SUBJECT: REQUEST FOR ADDITIONAL INFORMATION CONCERNING
DECOMMISSIONING PLAN FOR FACILITIES UNDER LICENSE
NO. 01-02861-04.

1. In a letter dated 27 July, 1995, the NRC, Region 2, requested additional information concerning the decommissioning plan for the hot cell, license No. 01-02861-04. The information in this memorandum addresses those parts of the plan the NRC requested additional information on.

SUBJECT: REQUEST FOR ADDITIONAL INFORMATION CONCERNING THE DECOMMISSIONING
PLAN FOR THE FACILITIES COVERED UNDER LICENSE NO. 01-02861-04

AFFECTED AREA

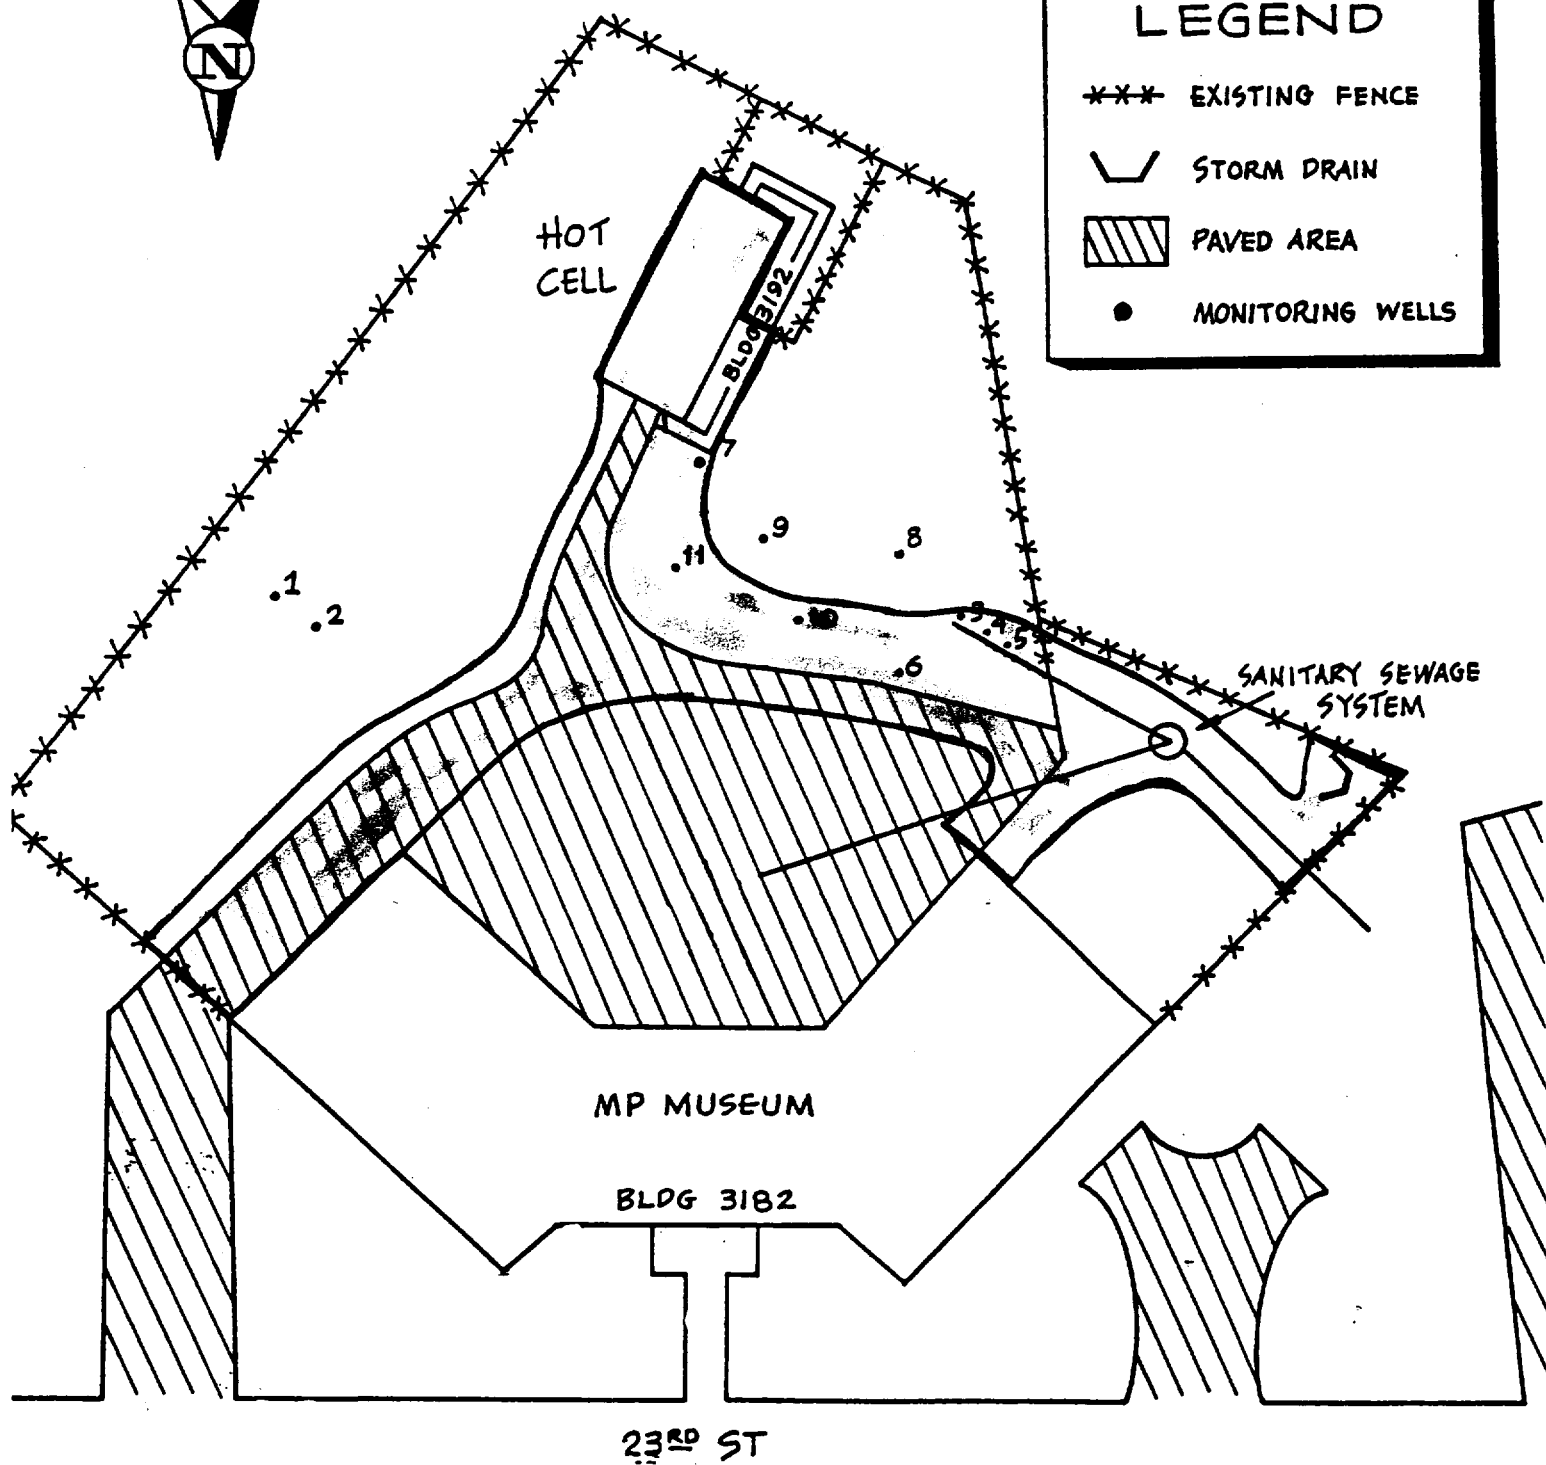
4. ATG illustrated the locations where they obtained soil samples in Figure 1 of their Sample Analysis Report dated January, 1995. Based upon their results and the sampling points as illustrated, it appears that soil contamination above NRC release criteria is present in areas near the fence perimeter at building 3182 (samples FM-043, -046 and -047) and along the sidewalk adjacent to building 3182 (samples FM-038 and -039).

Based upon the above, and the fact that this site has been the subject of previous remediation efforts, additional information regarding the final surveys is needed. Please describe (include diagrams) those areas within and around the facility that, for the purposes of this current decommissioning effort, are considered unaffected areas versus those that are considered affected areas as defined in NUREG/CR-5849, "Manual for Conducting Radiological Surveys in Support of License Termination" (enclosure 3). Also, please confirm that the final survey will be conducted as described in NUREG/CR-5849, or provide sufficient information to demonstrate that the final survey will provide the same level of assurance that the site meets the criteria for release for unrestricted use as provided by a final survey performed in accordance with the NUREG. Please note that the results of the final survey must be reported in the same units (i.e., dpm/100 cm², pCi/g, etc.) as those associated with the applicable release criteria.

5. Response to paragraph 4. For the purpose of this remediation, affected areas will include building 3192, paved areas inside the fence not previously surveyed, unpaved areas inside the fence not previously surveyed where radioactive material was used or stored. Affected areas include shaded areas on the attached diagram. All other areas are considered unaffected areas. Unaffected areas have no history of radioactive material use or storage and are not in the migration path for contamination. Affected areas will have a final survey conducted as described in NUREG/CR-5849. (see attached)
